SERVICE INSTRUCTIONS

SPARK IGNITION MODULE 028620 - for replacing original part #004316 gas fryer conversion

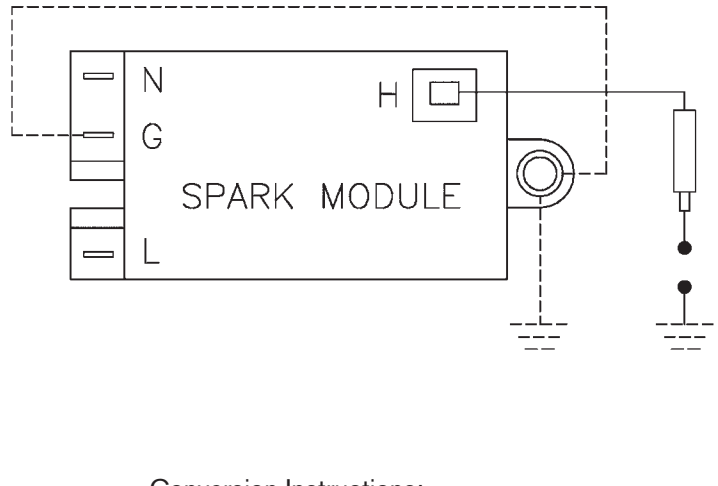
Conversion Instructions:

- 1 Connect to 2
- 2 Connect to 1
- 3 Blank
- 4 Connect Spark Electrode Wire
- 5 Equals "N"
- 6 Equals "L"
- 7 Connect to 9
- 8 Blank
- 9 Connect to 7
- 10 Blank
- 11 Blank
- 12 Connect to Ground

Conversion Instructions:

- N Equals "5"
- G Connect to Ground
- L Equals "6"
- H Connect Spark Electrode Wire
